**PLANNING & ZONING SECTION
STAFF REPORT**

Public Hearing Dates	P&Z Date: 05/27/2026	BCC Date: 06/16/2026
Case Number	260608ZP	
CDP-AR	PL PUD -000543-2026	
Type of Case	PUD Amendment with Concept Plan: Request to 1) Increase the number of proposed lots from 240 to 261 but not to exceed 321 lots; 2) Modify the number of units assigned to each of the three lot dimension options; 3) modify amenities; 4) Reduce the minimum front setback requirement from 25' to 20'	
Owner	Jax Road, LLC.	
Applicant	Tillman and Associates Engineering, LLC	
Street Address/Site Location	5823 NE Jacksonville Rd., Ocala, FL 34479	
Parcel Number(s)	14973-000-00 & 14971-001-00	
Property Size	±79.21 acres	
Future Land Use	Medium Residential (MR)	
Existing Zoning Classification	Planned Unit Development (PUD)	
Overlays Zones/Special Areas	Urban Growth Boundary (UGB), Primary Springs Protection Overlay Zone (P-SPOZ)	
Staff Recommendation	Approval with Conditions	
P&Z Recommendation	Approval with Conditions

Figure 2 - Proposed PUD Master Plan (260608ZP)

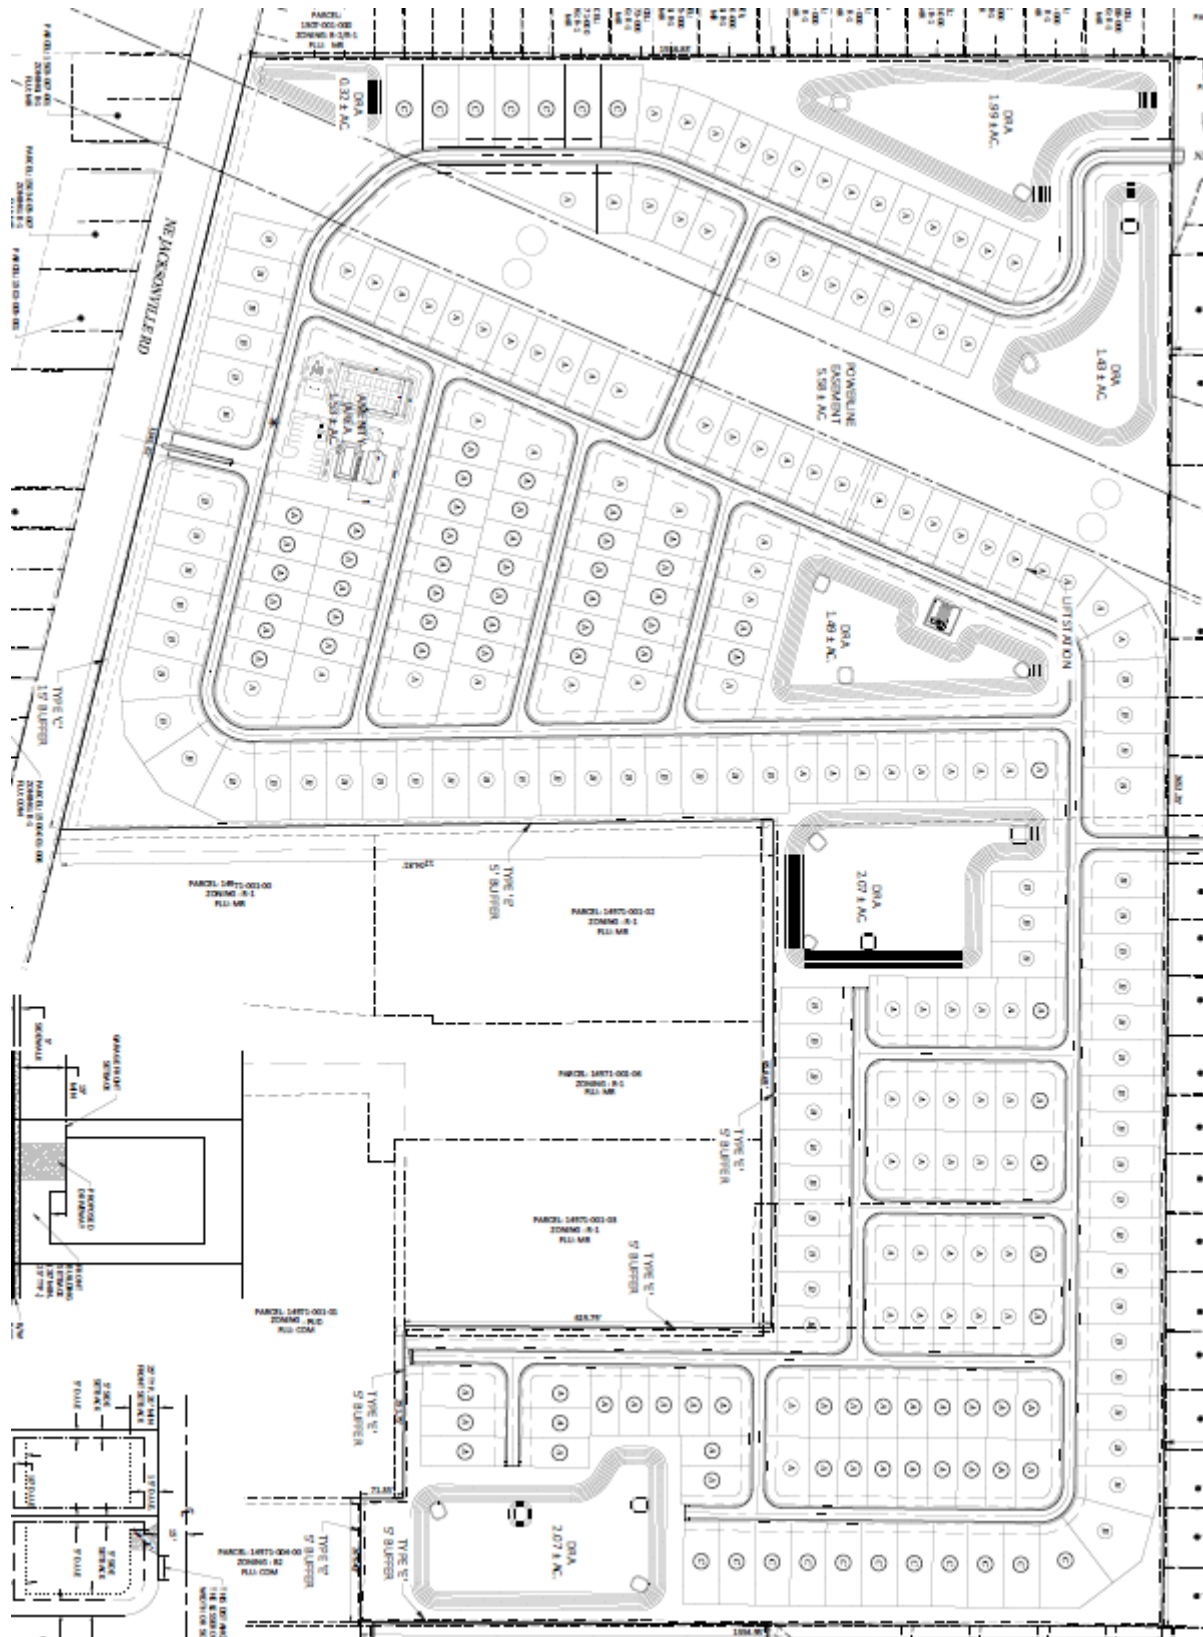
1. **An increase to the number of proposed lots:** The 2022 conceptual plan approved showed a total of 240 residential lots; however, the applicant requested approval for up to 321 residential lots. The requested approval is for 261 residential lots – but not to exceed 321 residential lots,.

2. **Modifications to the number of lots for each of the three lot dimension options:** The 2022 conceptual plan approved the following: 72 units at 50'x115', 81 units at 60'x115', and 87 units at 60'x140' for a total of 240 units. The updated concept plan proposes the following: 177 units at 50'x115', 66 units at 60'x115', and 19 units at 60'x140' for a total of 262 units. The application and concept plan differ by one lot.

3. **Modify Amenities:** The approved 2022 concept plan showed a 1.53-acre amenity area that included a 2,000 s.f. clubhouse with pool and playground and an activity field. The amenities modification includes the following items: Pickleball (activity) courts, a limited covered/shaded Playground Area with swing set and equipment, and a designated activity field.

4. **Reduce front setback requirement from 25' to 20':** The previously approved concept plan from 2022 required a 25' minimum front setback. The amended request is for a 20' minimum front setback.

The current PUD proposal seeks an increase in the number of single-family lots from the previously approved 240 units to 261 units; an increase of 21 lots. The parcel has a Medium Residential (MR) land use that allows 1-4 du/ac. At 79.21 acres, the land use could accommodate between 80 – 316 units. While the 261 units being sought fall within the range of allowable density, the additional request of, "but not to exceed 321 units," does not.

The request must be amended to be, “Increase the number of proposed lots from 240 to 261 but not to exceed 316 lots.” This would put all proposed figures within the range of possible density relative to the size of the property.

1. **[Modified]** The PUD shall consist of 261 detached single-family residential (SFR) dwelling units, up to a maximum total of 316 units, on 79.21 acres, and be consistent with the Concept Plan's listed development standards.
